Lahontan Regional Water Quality Control Board

PUBLIC REVIEW AND COMMENT OPPORTUNITY

**PROPOSED CAPTURE METRICS,
PACIFIC GAS AND ELECTRIC COMPANY'S
HINKLEY COMPRESSOR STATION
SAN BERNARDINO COUNTY**

CLEANUP AND ABATEMENT ORDER (CAO) NO. R6V-2015-0068

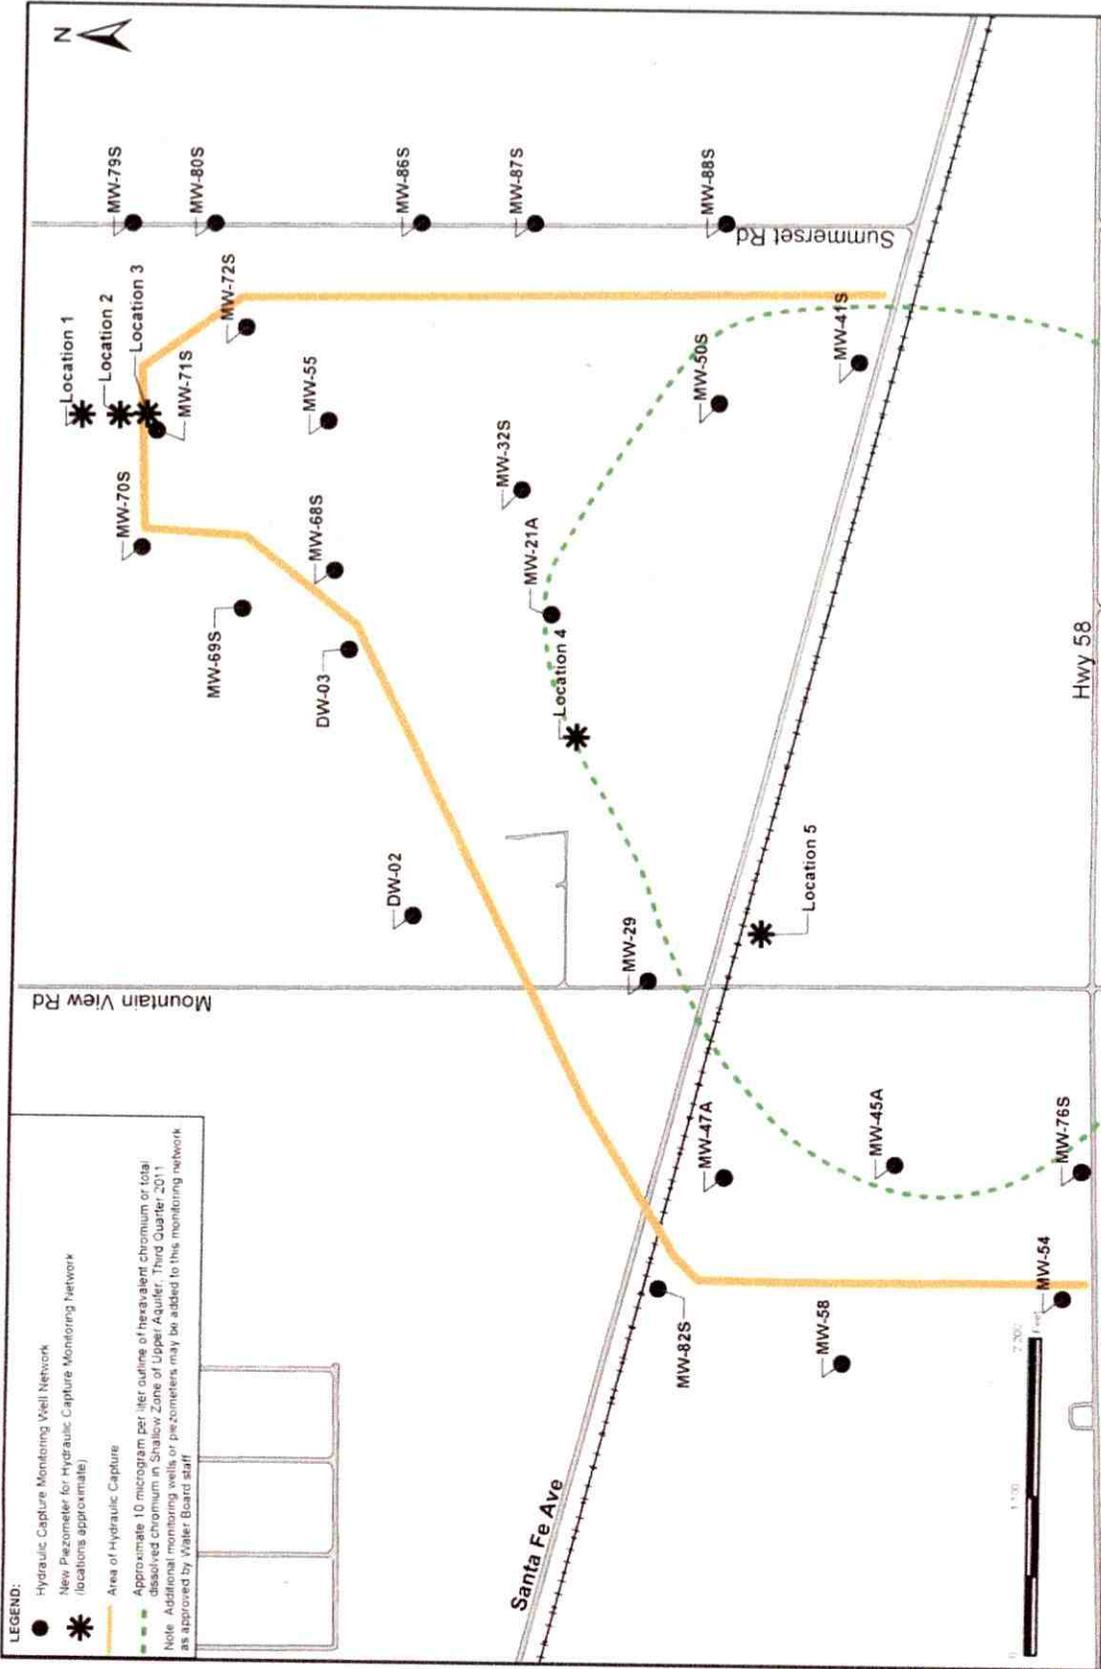
The Water Board is seeking comments on proposed capture zone revisions to CAO R6T-2015-0068 (Enclosure 1). Order V.F. in the CAO allows the Executive Officer to approve alternate hydraulic capture zones and metrics upon demonstration of decreasing chromium concentrations and reduction in size of chromium plume boundary lines. Current compliance with plume containment requirements, cited in Order V.C., are determined by (1) comparing hydraulic gradients or groundwater flow direction vectors calculated from groundwater elevation data from select well pairs/triplets and piezometers as outlined in Attachments 5-7 and (2) comparing the 50 ppb hexavalent chromium/total chromium [Cr(VI)/Cr(T)] and 10 ppb Cr(VI)/Cr(T) boundaries to plume maps as of the date of the CAO (November 4, 2015). PG&E has submitted information to the Water Board requesting revision of Attachments 5-7 in the CAO.

FIGURE
A-1

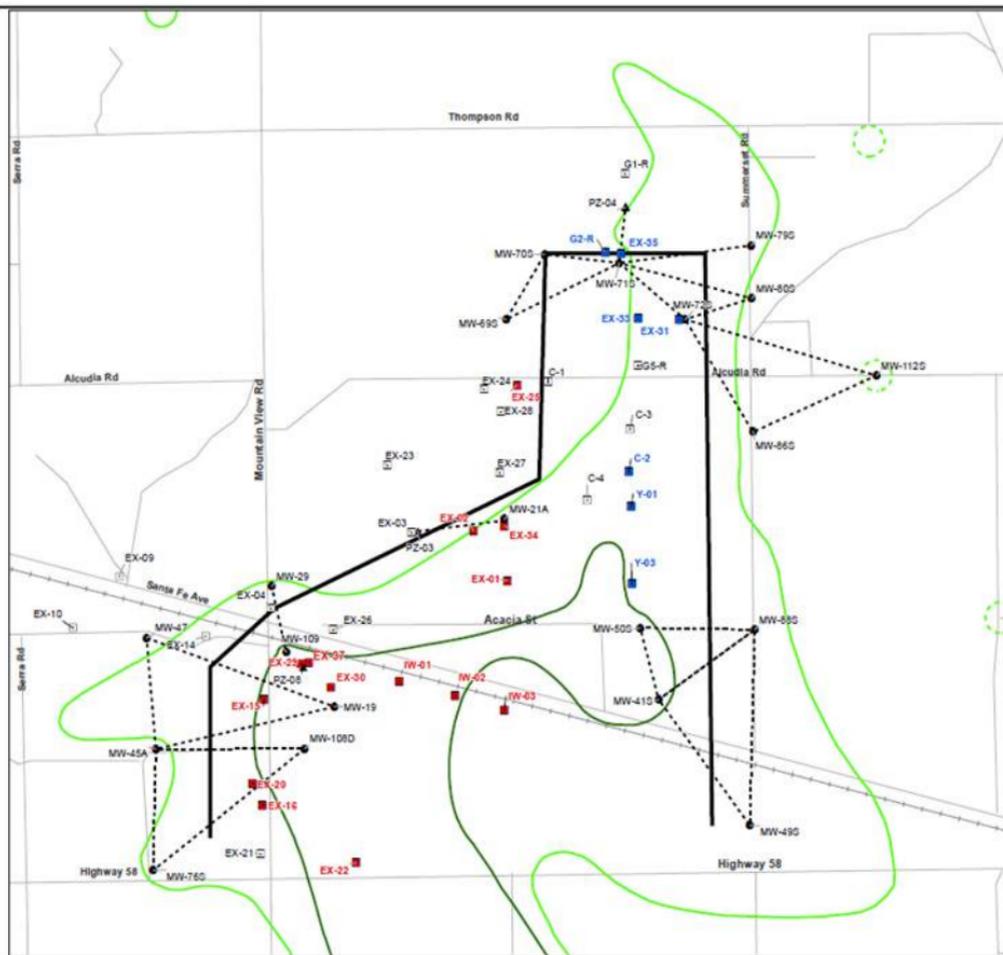
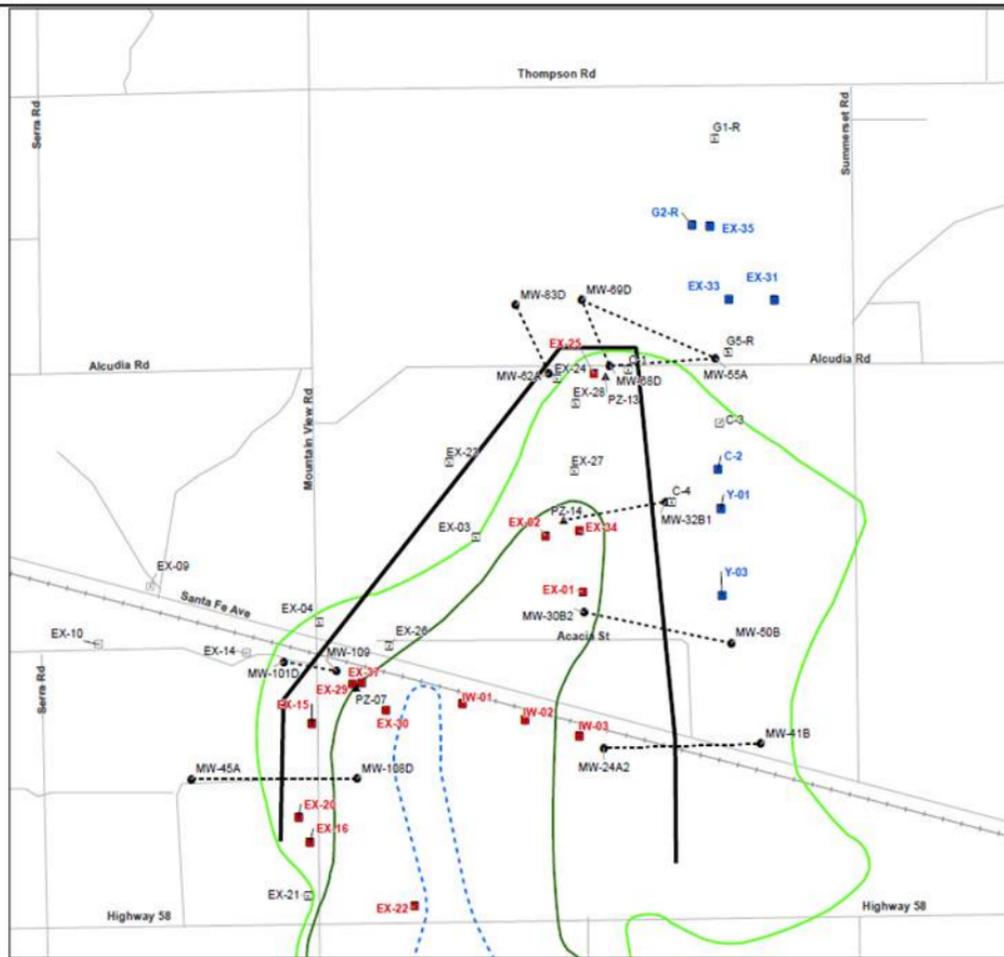
The need for the revised capture zones and metrics is to hasten cleanup of chromium by focusing groundwater pumping at Santa Fe Road and southwards while reducing the pumping rate of the northern groundwater extraction system between Santa Fe Road and Thompson Road, where groundwater has mostly been remediated. Such actions will reduce excessive groundwater drawdown, northward movement of the chromium plume, and expedite cleanup. Should plume capture not be demonstrated or chromium concentrations increase significantly north of the proposed capture zones, PG&E proposed a contingency plan in the April 20, 2016 document, "Results for Winter 2015-16 Hydraulic Testing Event and Recommendations for Alternate Capture Zones (Results)." The contingency plan states that step-out monitoring and additional extraction, if needed, will be used to contain potential chromium migration.

Hydraulic capture shall be demonstrated through analysis of potentiometric surfaces in the A1 and A2 layers of the upper aquifer measured at least monthly. Hydraulic capture shall be demonstrated using those monitoring wells or piezometers identified in Table A-1 or other wells accepted by Water Board staff. For well pairs, the inner well must have a potentiometric surface lower than the outer well. For well triplets, the vector described by the potentiometric surfaces at the three wells must show a gradient directed inward of the capture boundary line shown on Figures A-1 and A-2 for the A1 and A2 depth layers, respectively.
